**VILLAGE OF LOMBARD
INTER-DEVELOPMENTAL REVIEW GROUP REPORT**

SPA 11-02ph: 85 Yorktown Shopping Center (Chase Bank): The petitioner requests Site Plan Approval with the following deviations for the subject property located within the B3 Community Shopping District and Yorktown Center Planned Development:

SUBJECT: Proposed Chase Bank Branch Traffic Evaluation
Lombard, Illinois

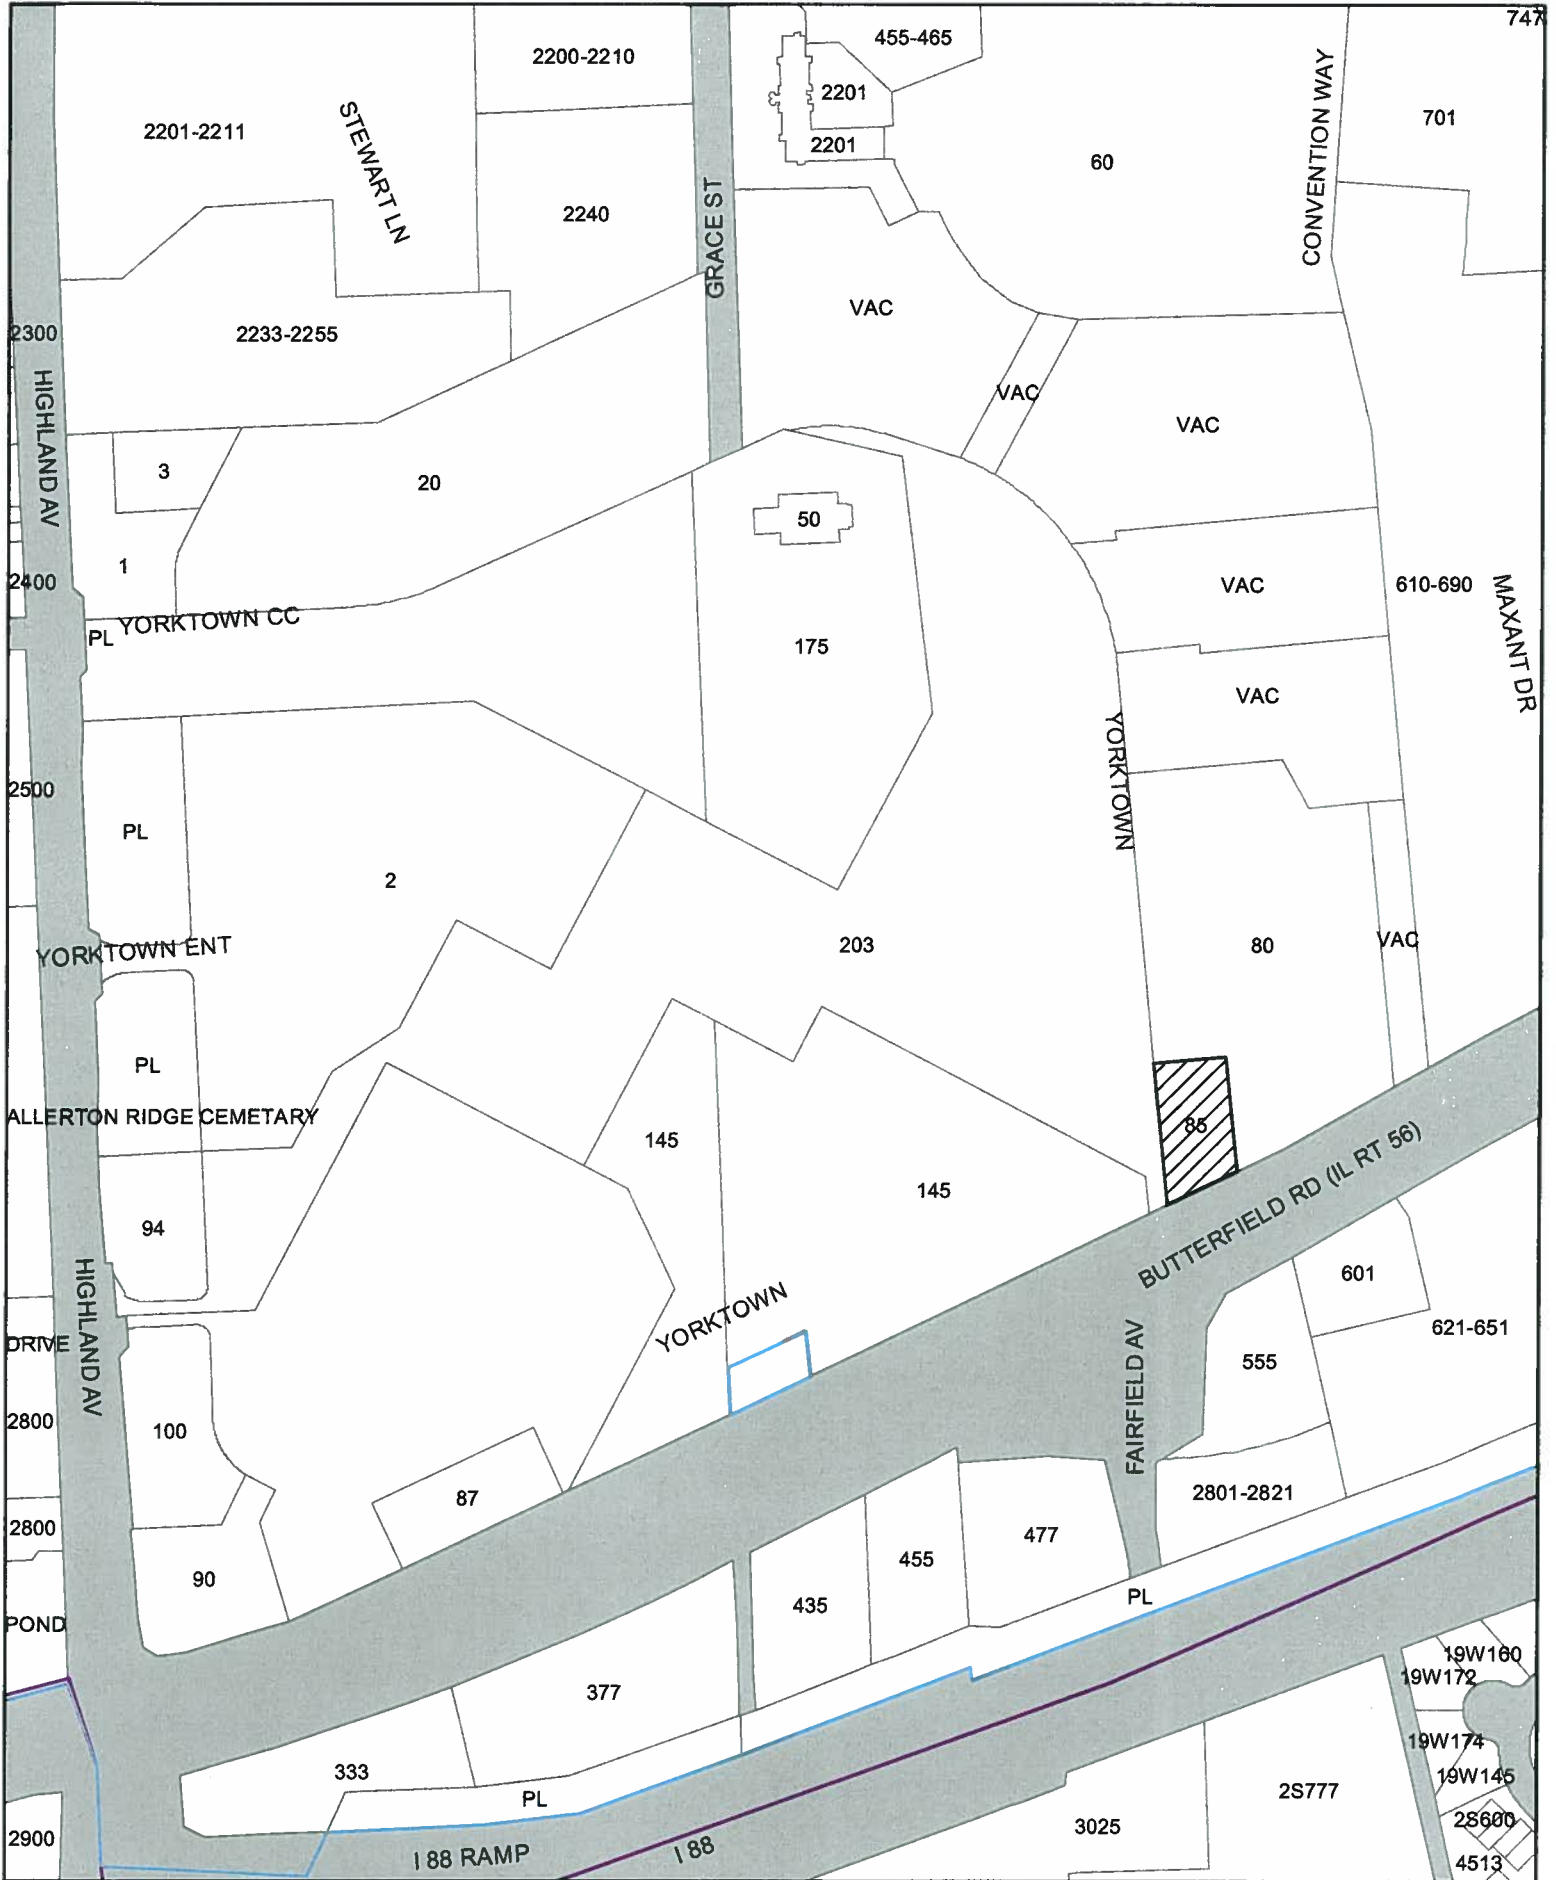
This drive access drive is located approximately 200 feet from Butterfield Road and, more importantly, only 70 feet from the intersection of Fairfield Avenue with the Yorktown Shopping Center ring road. The right in is important in that it quickly and efficiently serves inbound customer traffic destined to the bank. Based on a number of detailed and comprehensive traffic studies at Yorktown, inbound traffic, even though not required to stop at the ring road, experiences significant backups making it very difficult and unsafe for outbound site traffic to exit from the right-in/right-out access drive. For bank customer traffic desiring to enter the shopping center, there are other alternative driveways which can be utilized. As such, it is recommended that this driveway be restricted to right turns in only.

This full access driveway is located approximately 70-80 feet from the stop bar for southwest traffic on the Yorktown Shopping Center ring road at its intersection with Fairfield Avenue. Our previous studies and analyses of traffic at this location indicate significant backups in traffic trying to exit the center as well as high volumes and speeding along this section of the inbound ring road. As such and from a safety standpoint, it is recommended that the bank consider restricting this driveway to right turns in and out only. This would simplify traffic operations along the ring road and reduce the number of conflict points within close proximity to the intersection of Fairfield Avenue with the Yorktown Shopping Center ring road.

- Circulation within the site is fairly well defined.
- Based on the recommended changes in site access, additional internal signage should be provided directing customers to the various driveways serving the site.
- Drive-through stacking for four vehicles at each window is more than adequate. Studies by KLOA, Inc. at a number of banking facilities has indicated much lower stacking needs.
- The number of parking spaces provided is more than adequate.
- Sign number 6 on the "Sign Location Plan" should be moved further north to provide a better site line to incoming drivers.
- Additional signs directing customers to the drive-through facility may be desired at the other access drives to the site.
